Bulletin No.: PI1522

## **Service Bulletin**

# **PRELIMINARY INFORMATION**

**Subject:** Malfunction Indicator Lamp (MIL) ON, Poor Transmission Shift Performance/Quality

4251829

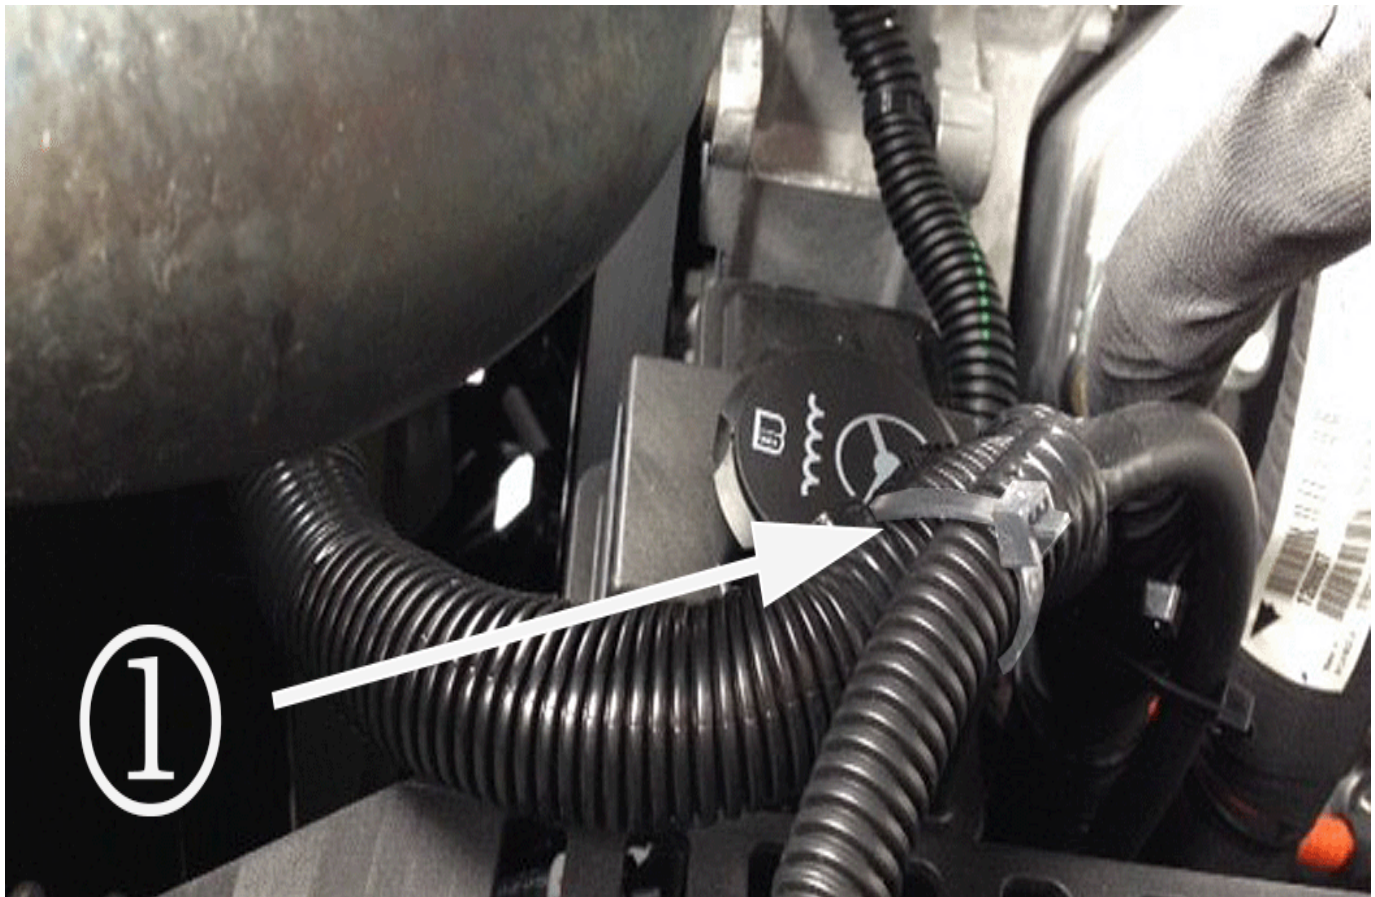
The TCM wire harness routing allows interference with the engine accessory drive belt, which can cause damage to the wire harness.

See the picture below of a damaged harness.

Repair the TCM harness as required.

Secure the harness away from the engine accessory drive belt by tie strapping it to the battery negative cable. See the picture above of a tie strapped (1) harness.
